**BOROUGH OF CARROLL VALLEY  
PLANNING COMMISSION MEETING  
Monday, November 13, 2023 – 7:00 P.M.  
Borough Office**

**Subject:** Subdivision and Land Development Plan Review  
Ski Liberty Operating Corp.  
Preliminary/Final Subdivision and Land Development Plan  
115 Sanders Road Fairfield, PA 17320  
Plan date: July 20, 2023 (revised 10-10-23)

**Date:** November 8, 2023

Title  
GRADING AND UTILITY PLAN

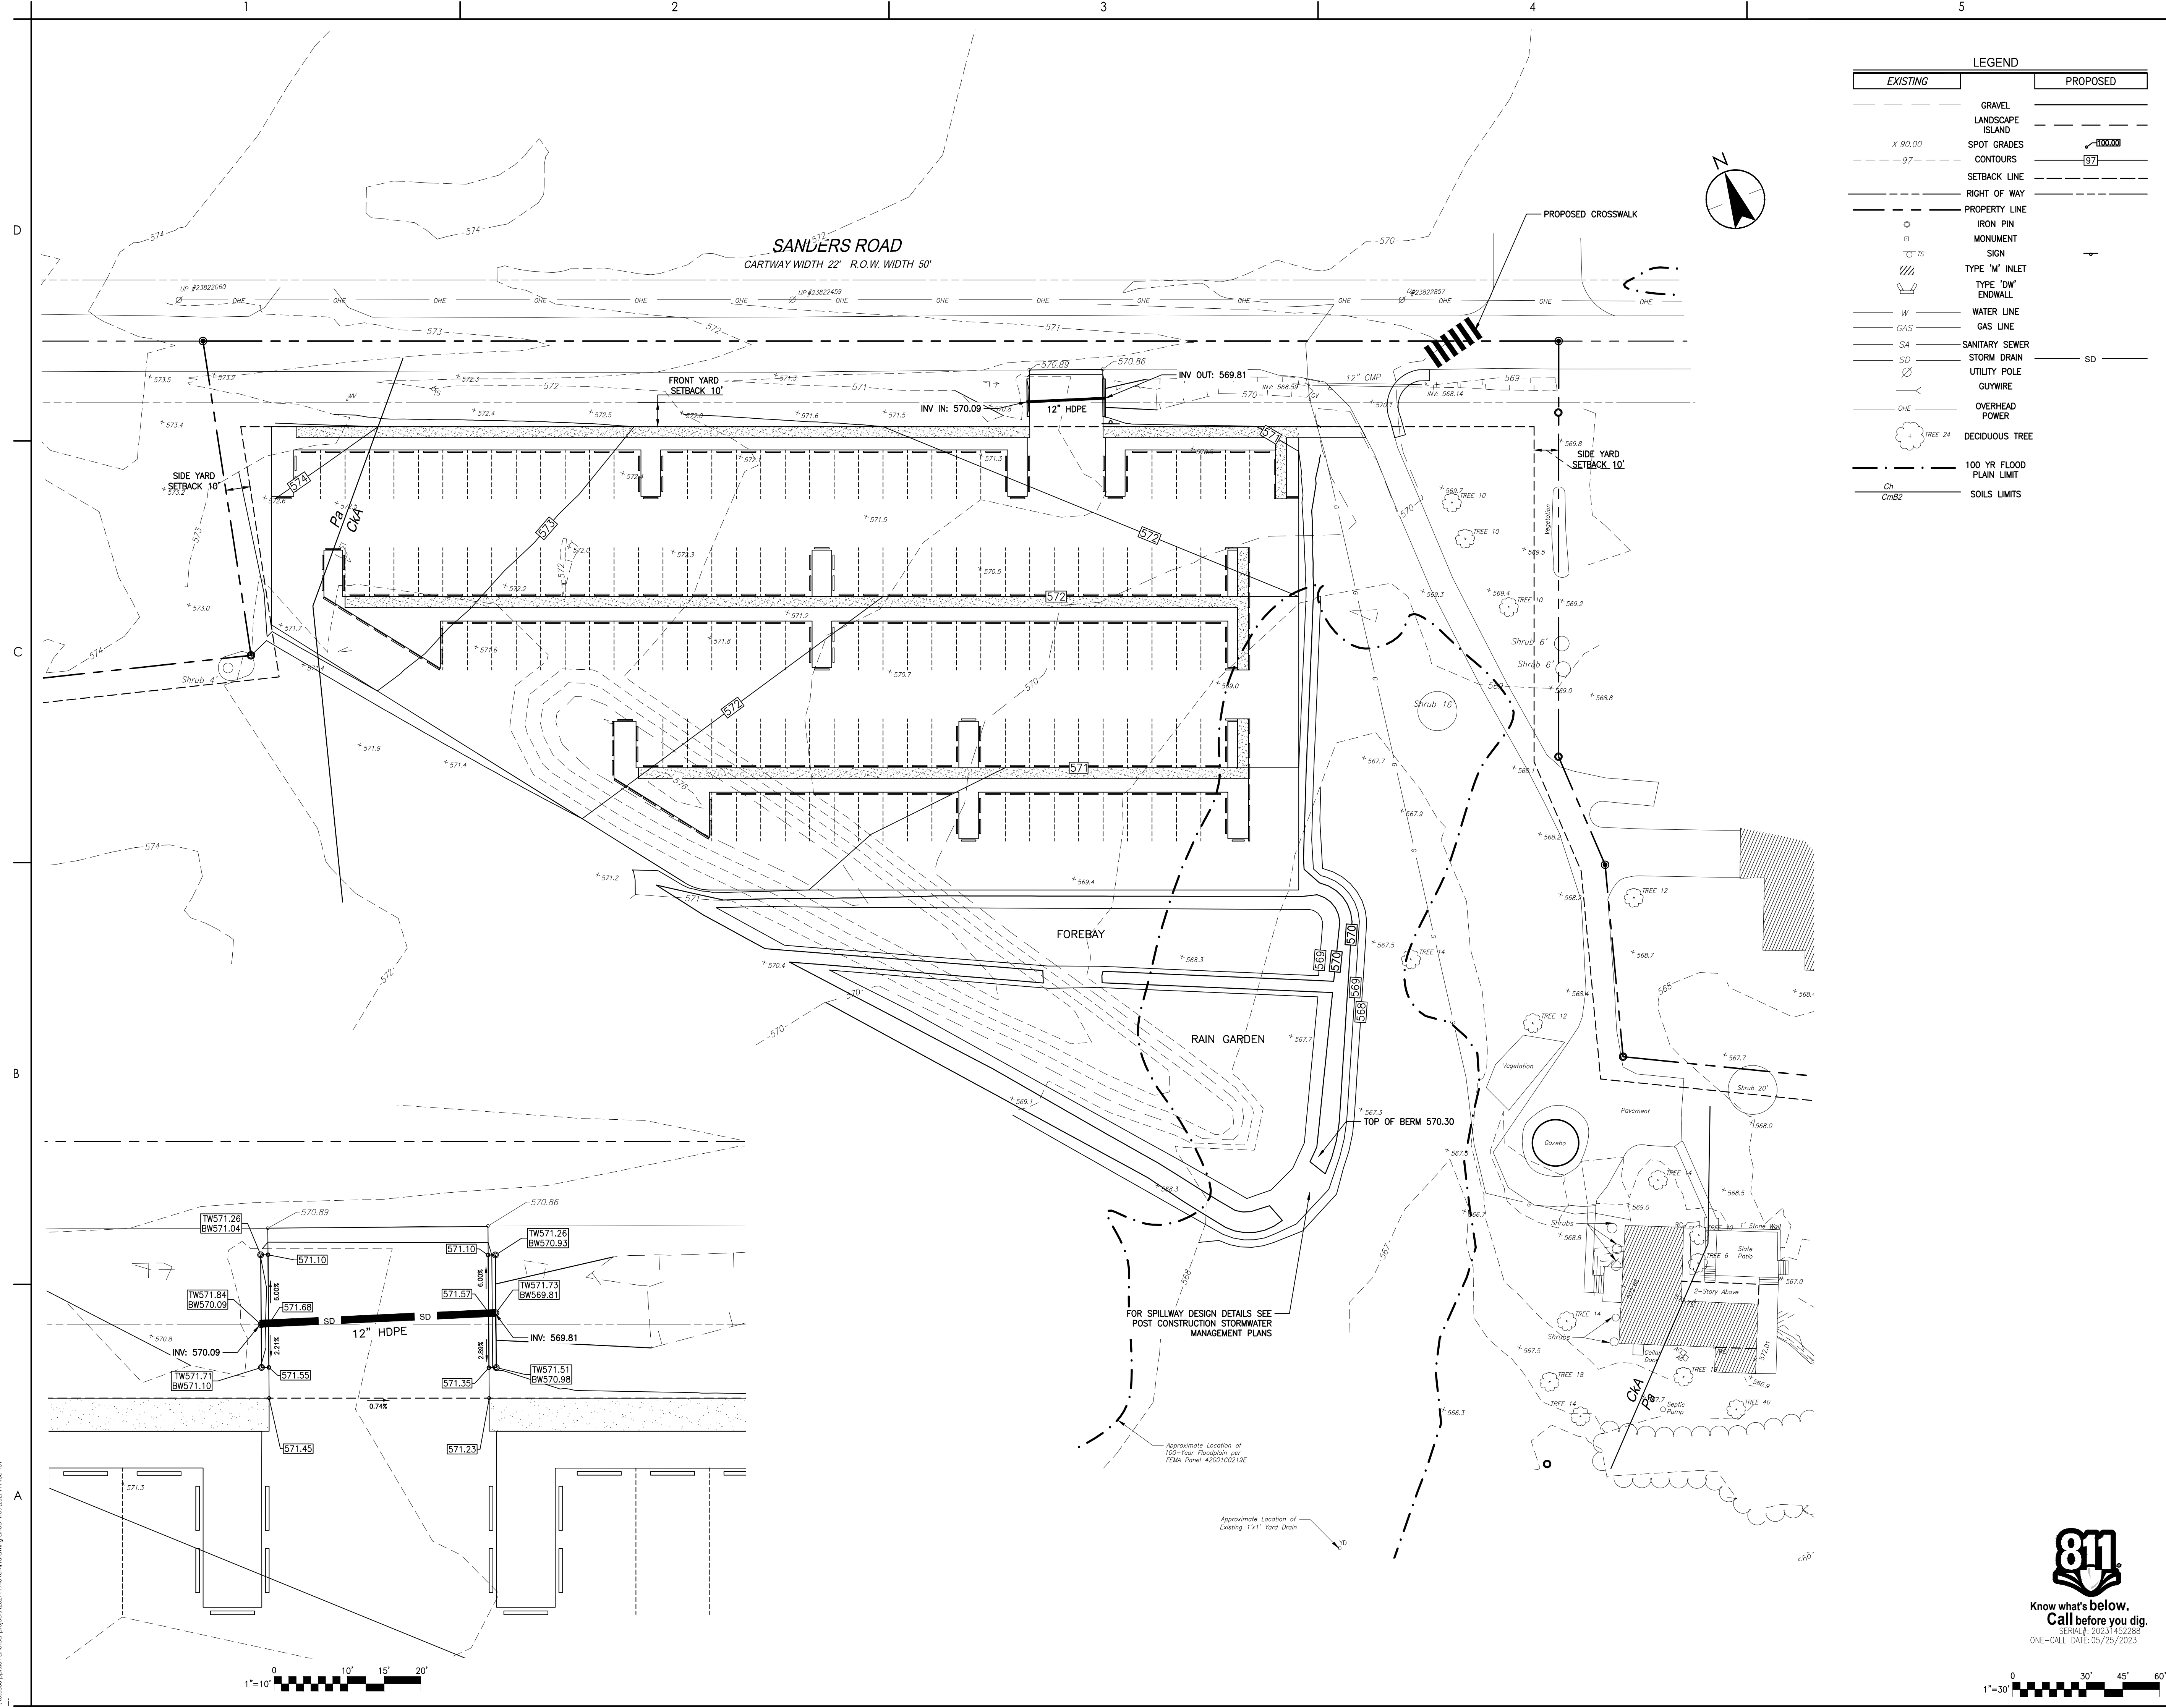
21. *On sheet C-142, it appears that steps #17-26 of the "General Construction Sequence" are out of place. Please revise for consistency with this project and appropriate order of construction.*

22. *There appears to be multiple construction sequences for the construction of the raingarden. "Critical Stage of Construction - Rain Garden Infiltration BMP" on sheet C-142 and C-162, as well as a construction sequence under the "Rain Garden / Bioretention Zone" Detail on sheet C-162. There should be one sequence to follow for construction of the raingarden with the critical stages outlined. Additionally, the sequence should be site specific, as it appears that the "Critical Stage of Construction - Rain Garden Infiltration BMP" mentions an infiltration bed and geotextile.*

**The general construction sequence on sheet C-142 has been updated to more appropriately reflect the order of construction.**

**The duplicate copy of the "critical stages of construction" notes have been removed from C-162. Also, the construction sequence under the "Rain Garden / Bioretention Zone" detail on sheet C-162 has been revised to be specific to Planting Installation. In addition, the "critical stages of construction" on sheet C-142 have been updated to be site specific.**
